Amendment No. 0001
27 February 2003

SUBJECT: Amendment No. 0001 to Specifications and Drawings for Construction of
Install Transformer, Fort Peck Power Plant, Fort Peck, MT
Solicitation No. DACW45 03 B 0006.

Install Transformer
Fort Peck Power Plant, Fort Peck, MT

PHOTO NO.2
 EXISTING AUTO-TRANSFORMER NO.1
 VIEW OF 13.8KV TERTIARY BUS CONNECTIONS

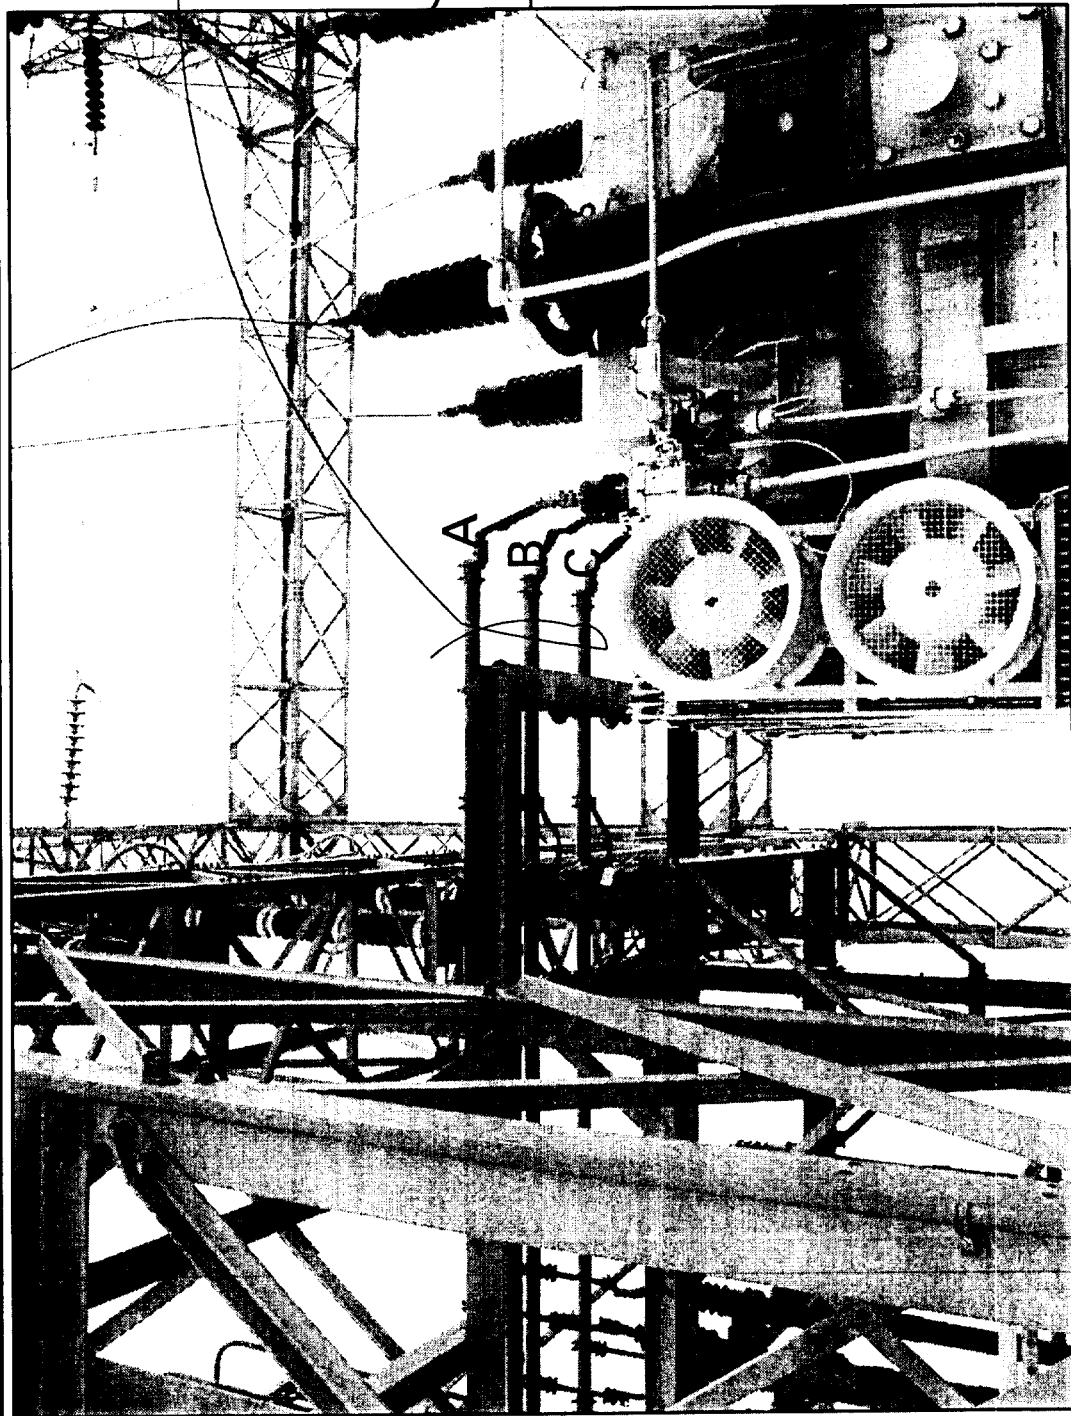
3. THE EXISTING PHASING IS C - B - A AS MARKED ON THE PHOTO NO. 2. THE CONTRACTOR SHALL TRANSPOSE THE 3" COPPER TUBING SO THAT WHILE FACING THE NORTH SIDE OF THE NEW TRANSFORMER THE FINAL PHASING SHALL BE A - B - C.

Symbol	Descriptions	Date	Approved
	AMENDMENT NO. 1 - ADDED PHOTO2 & NOTE 3	02/20/03	R. J. B.

Amendment 1 drawing MFP211-93E-3

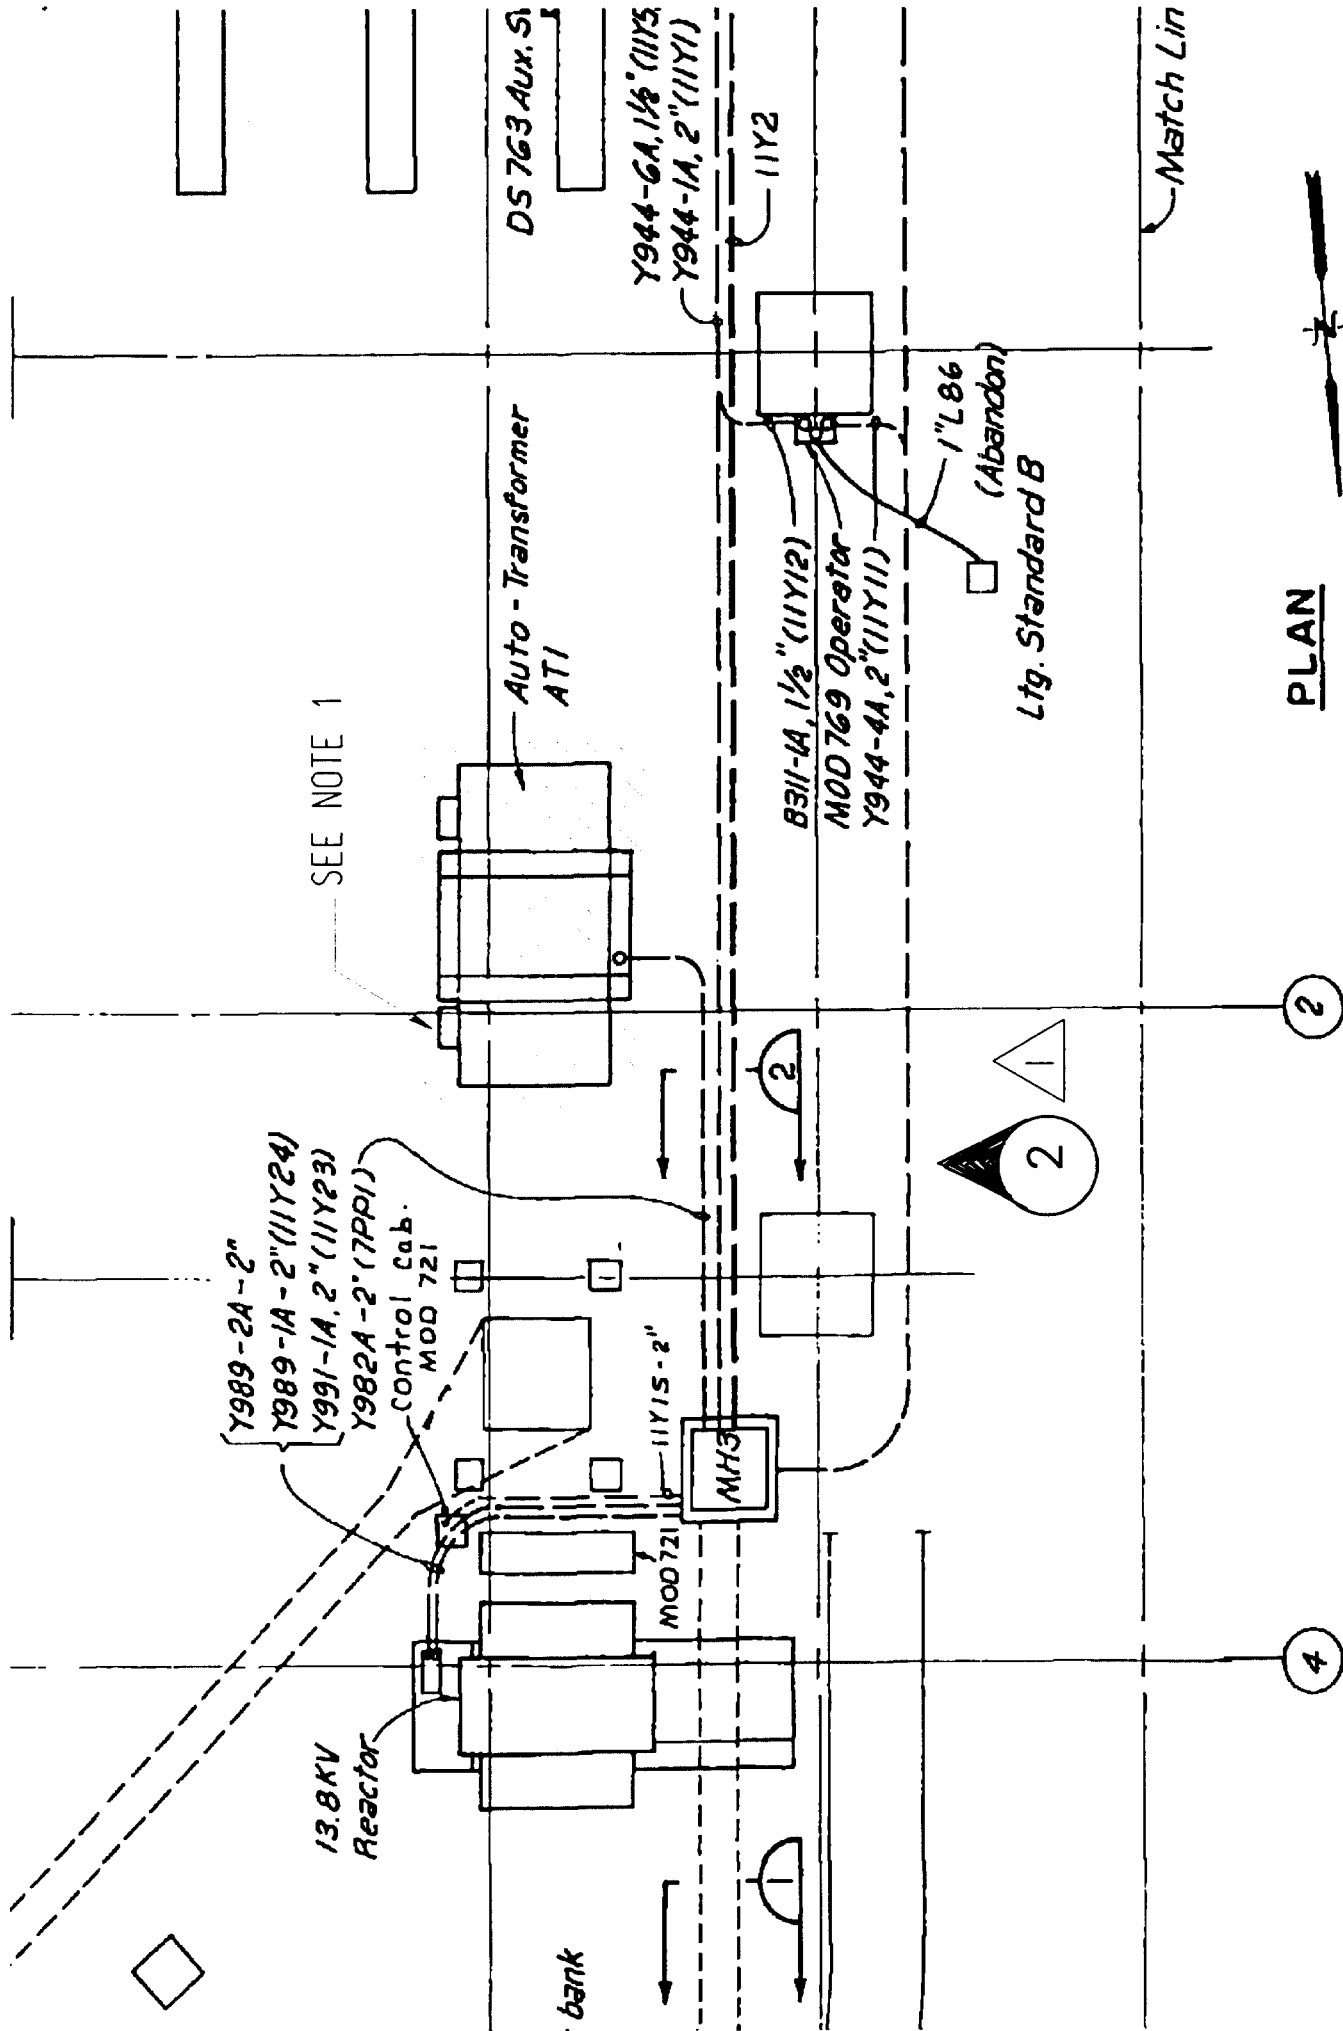
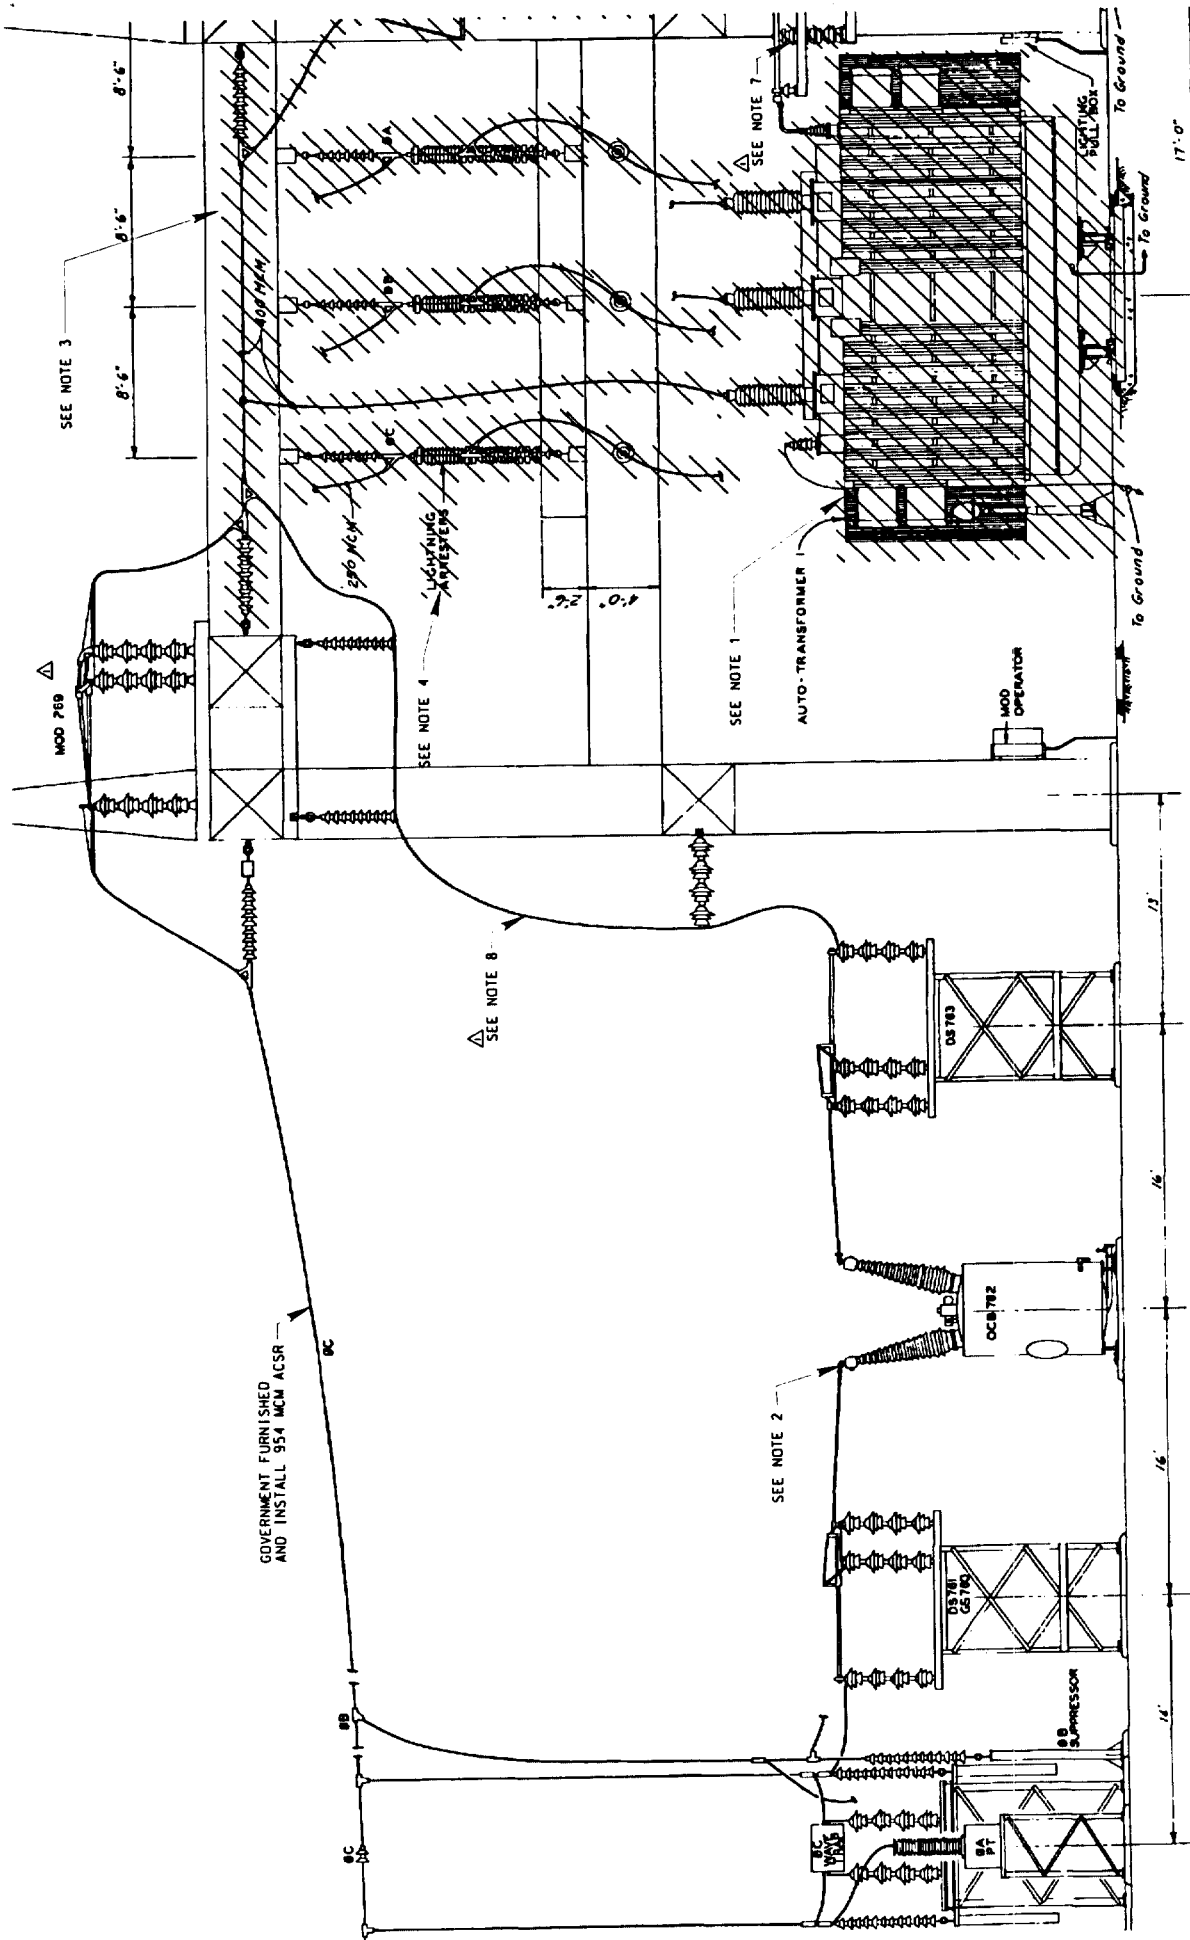
1. THE CONTRACTOR SHALL REMOVE THE EXISTING AUTO-TRANSFORMER NO. 1.
2. THIS DRAWING HAS NOT BEEN UPDATED TO SHOW THE NEW GAS CIRCUIT BREAKERS (GCB). THE OLD CIRCUIT BREAKERS ARE BEING REPLACED WITH A MITSUBISHI ELECTRIC POWER PRODUCTS TYPE 200-SENT-40E/40HE DESIGNATED AS GCB 762 AT THE SAME TIME THESE DRAWINGS ARE BEING PREPARED.
3. THE CONTRACTOR SHALL REMOVE THE UPPER LEVEL 161KV BUS FOR REUSE AS A 115KV BUS WHICH WILL BE ORIENTED 90° FROM ITS PRESENT POSITION. SEE SHEETS E-10, E-11, & E-13.
4. THE CONTRACTOR SHALL REMOVE EXISTING 115 KV LIGHTING ARRESTERS.
5. THE CONTRACTOR SHALL REMOVE EXISTING 161 KV LIGHTING ARRESTERS.
6. SEE FOR INFORMATION ONLY DRAWING MFP-OPN93E105.3 FOR WHERE THIS SECTION CUT IS MADE.
7. THE CONTRACTOR SHALL REMOVE THE EXISTING 13.8KV SURGE ARRESTERS.
8. THE CONTRACTOR SHALL REMOVE THE EXISTING 161KV CABLE AND REPLACE WITH 954 MCM ACSR CABLE.

Amendment 1 drawing MFP211-93E-4

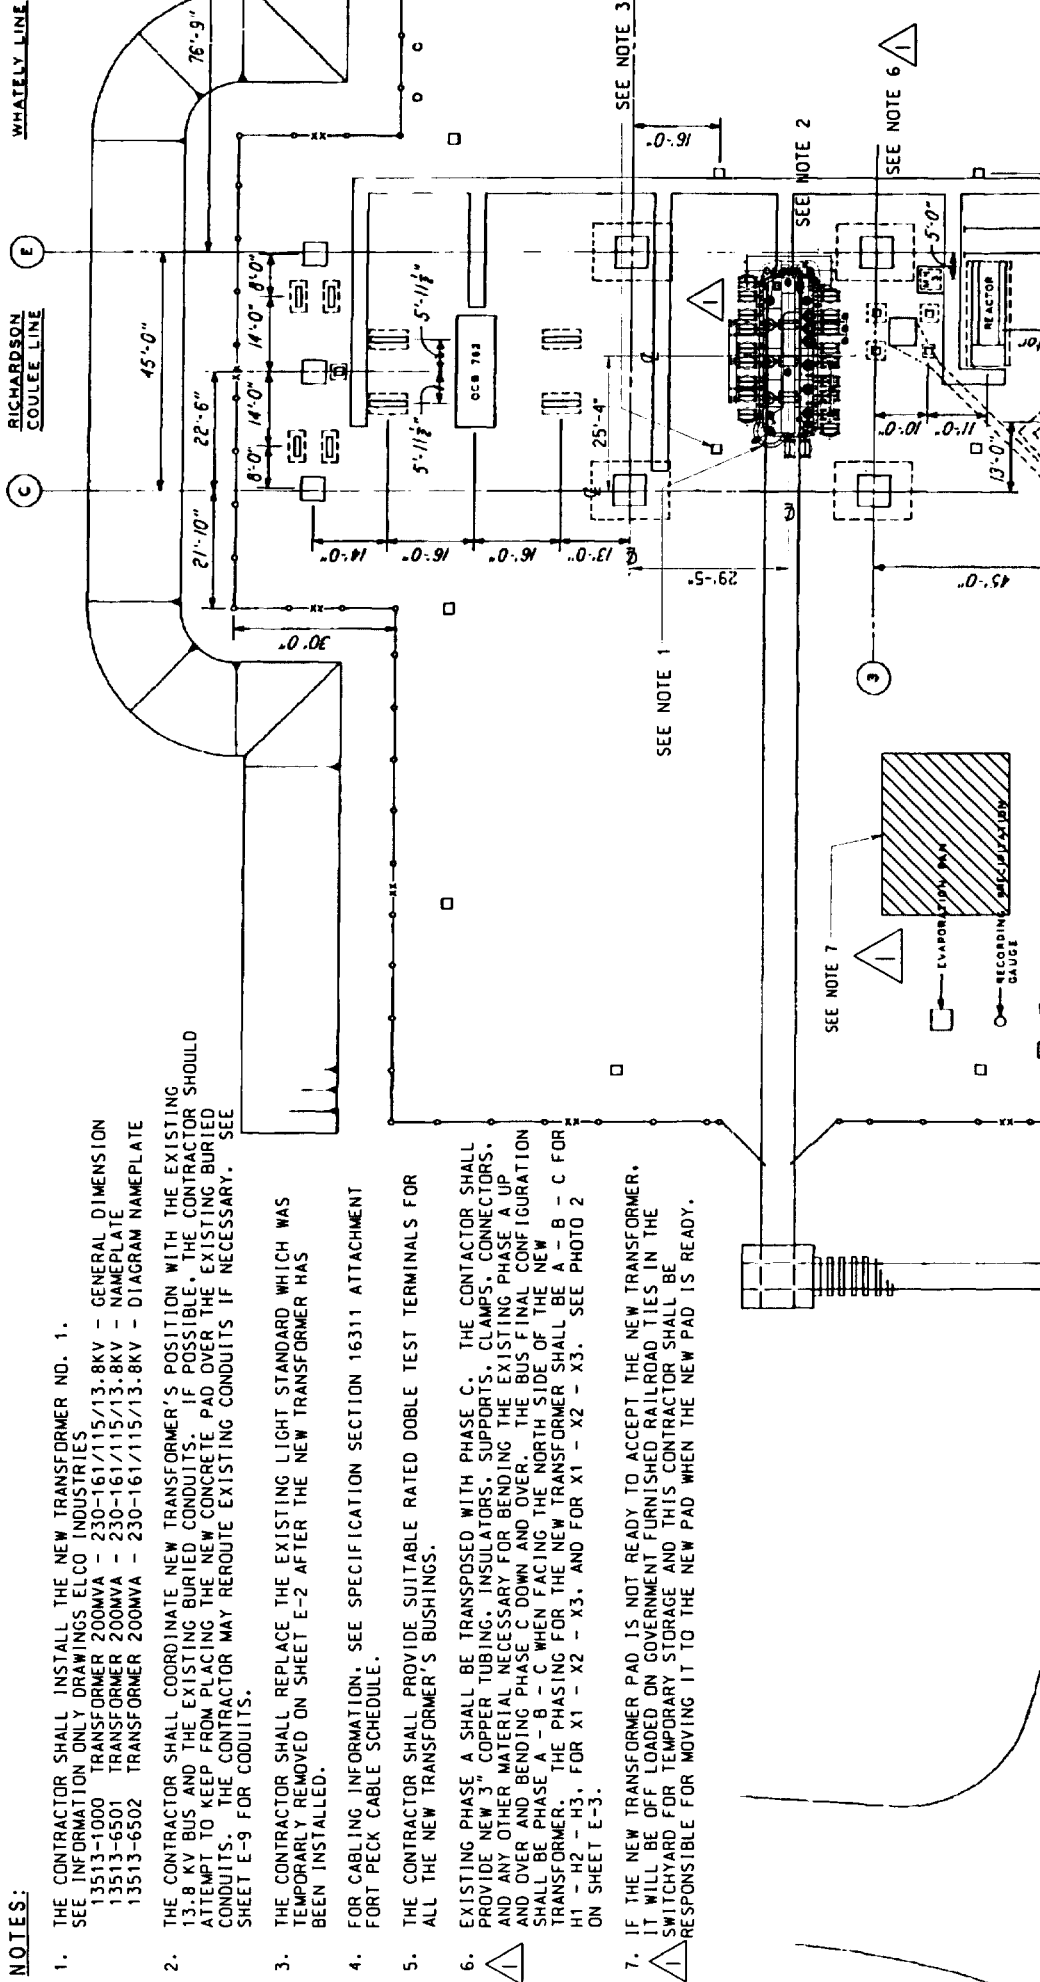
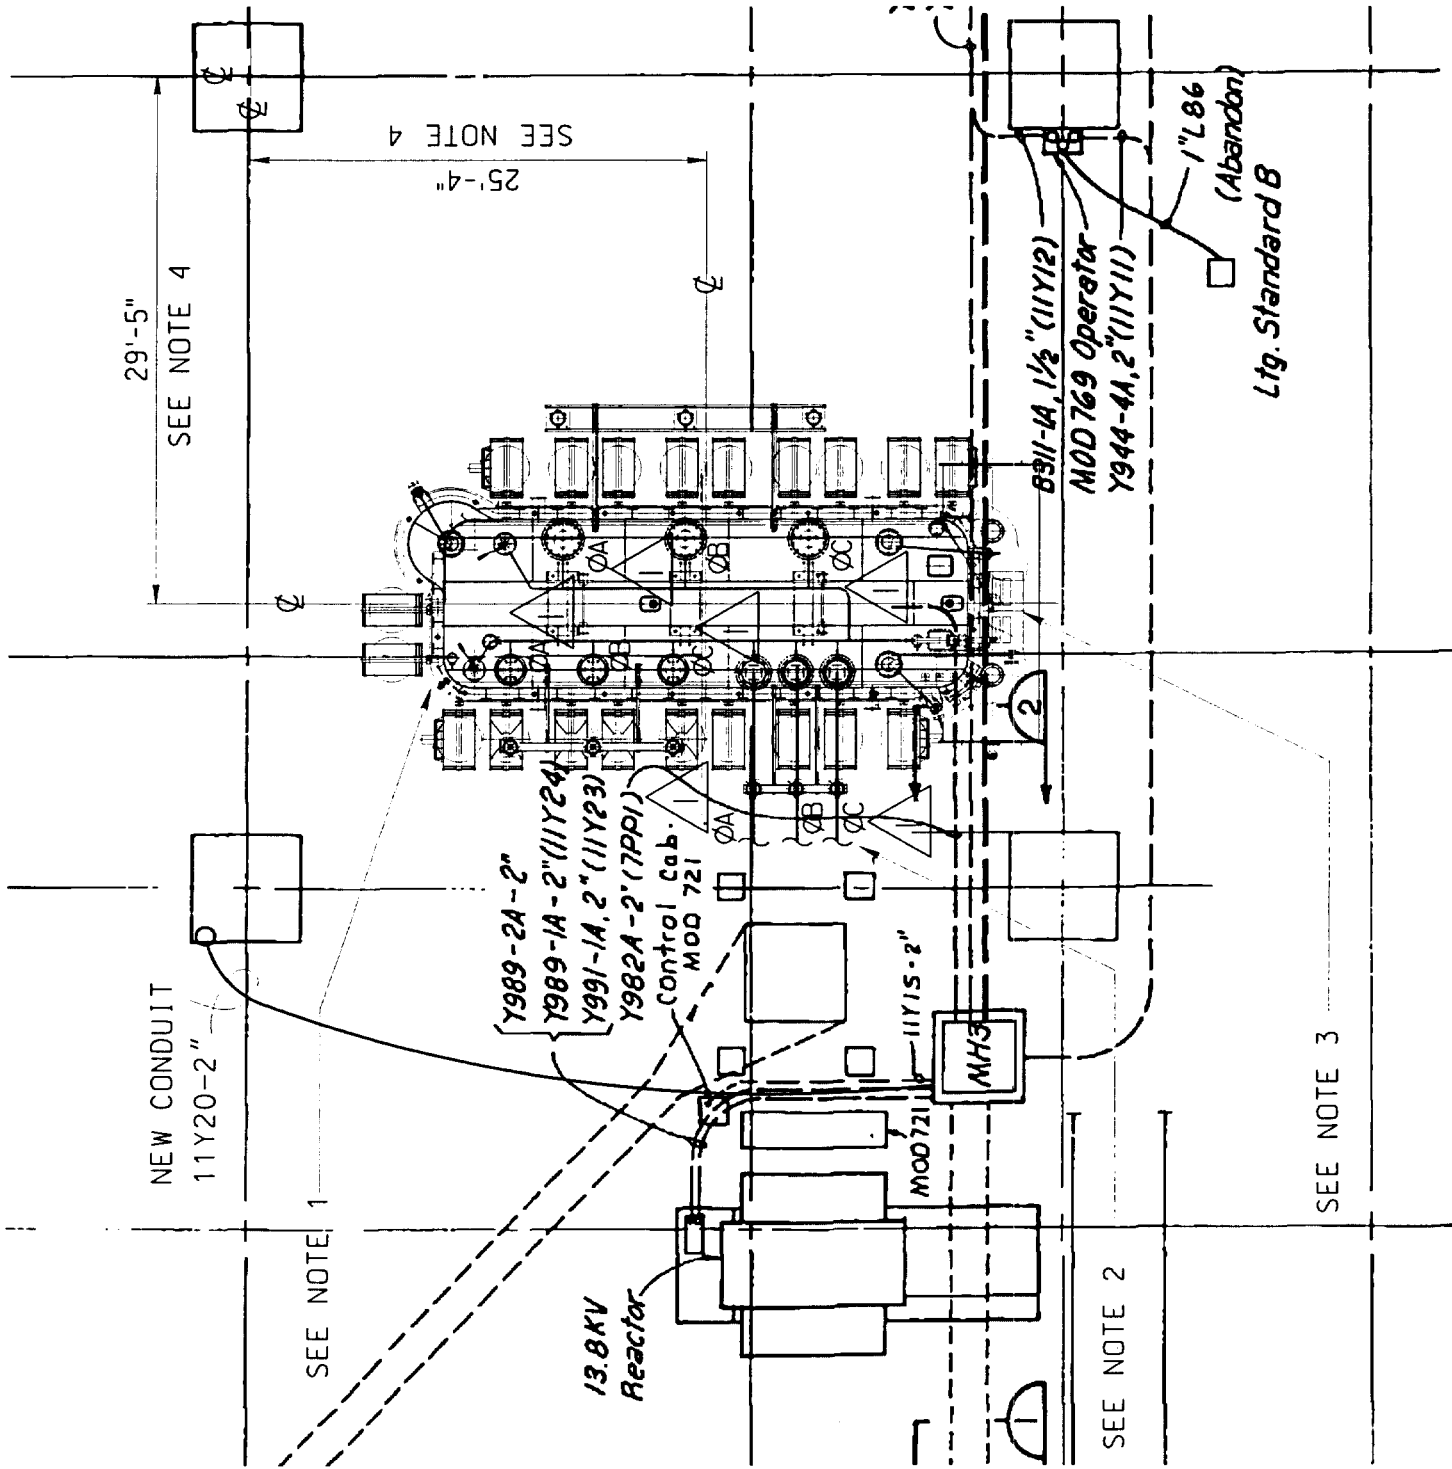
5. THE CONTRACTOR SHALL PROVIDE SUITABLE RATED DOBLE TEST TERMINALS FOR ALL THE NEW TRANSFORMER'S BUSHINGS.
6. EXISTING PHASE A SHALL BE TRANSPOSED WITH PHASE C. THE CONTACTOR SHALL PROVIDE NEW 3" COPPER TUBING, INSULATORS, SUPPORTS, CLAMPS, CONNECTORS, AND ANY OTHER MATERIAL NECESSARY FOR BENDING THE EXISTING PHASE A UP AND OVER AND BENDING PHASE C DOWN AND OVER. THE BUS FINAL CONFIGURATION SHALL BE PHASE A - B - C WHEN FACING THE NORTH SIDE OF THE NEW TRANSFORMER. THE PHASING FOR THE NEW TRANSFORMER SHALL BE A - B - C FOR H1 - H2 - H3, FOR X1 - X2 - X3, AND FOR X1 - X2 - X3. SEE PHOTO 2 ON SHEET E-3.

7. IF THE NEW TRANSFORMER PAD IS NOT READY TO ACCEPT THE NEW TRANSFORMER, IT WILL BE OFF LOADED ON GOVERNMENT FURNISHED RAILROAD TIES IN THE SWITCHYARD FOR TEMPORARY STORAGE AND THIS CONTRACTOR SHALL BE RESPONSIBLE FOR MOVING IT TO THE NEW PAD WHEN THE NEW PAD IS READY.
